Site (Plot) Plan

Project Address: 1853 Kinneloa Canyon Road
Pasadena, California

Figure 1

JOB NO.
11-276-006

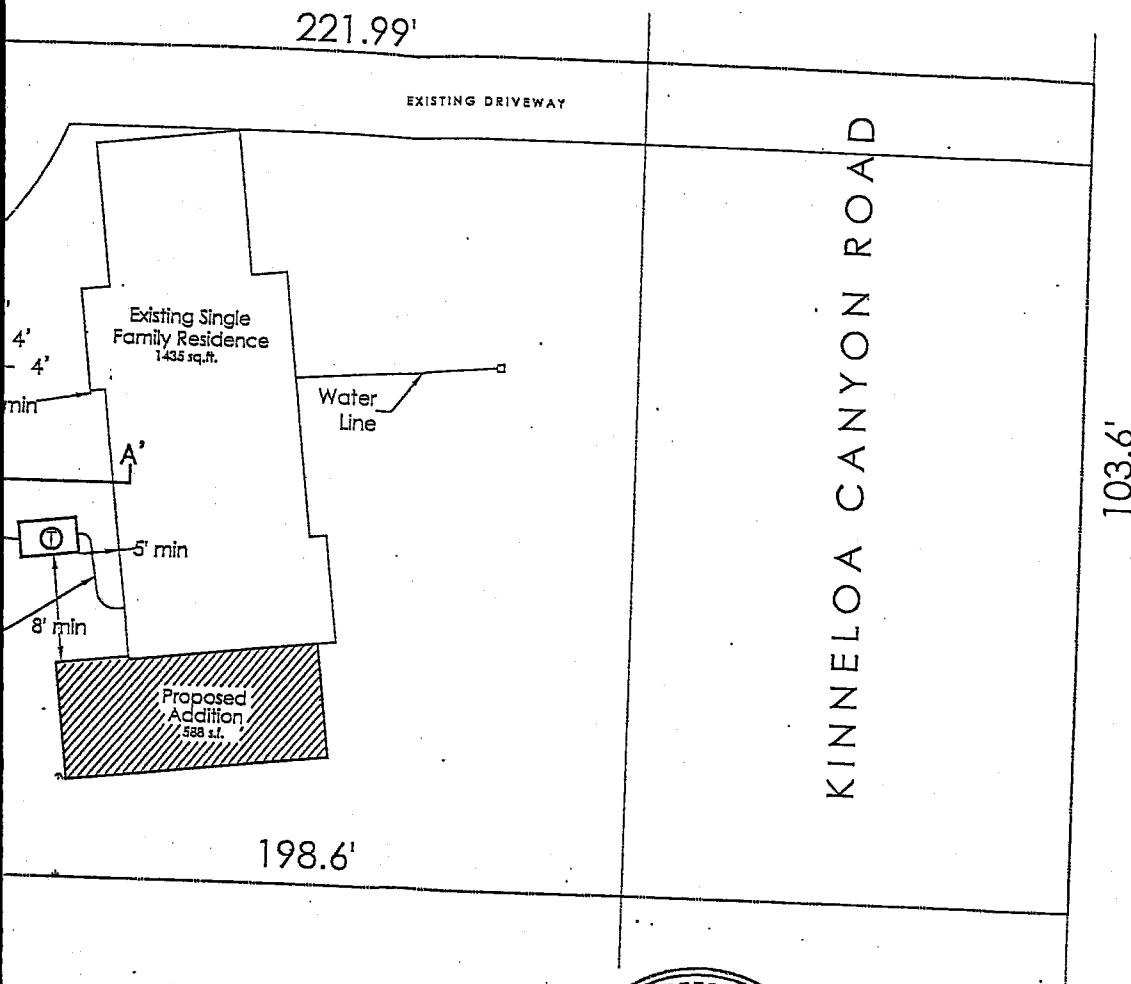
NOTE: At the time of installing the future seepage pit the septic tank
should be upgraded to a supplemental treatment tank due to the
fast percolation rate

1. This is an approval of a 100% future expansion area for a seepage pit.
2. This approval is in connection with the remodel/expansion of an existing three bedroom house which is to remain three bedrooms.
3. When the present system fails the 100% future expansion pit will be activated. It is recommended that a denitrification system be installed to replace existing septic tank when future seepage pit is installed at the site.
4. A new plot plan will be resubmitted to indicate the specific advanced treatment system to be installed.
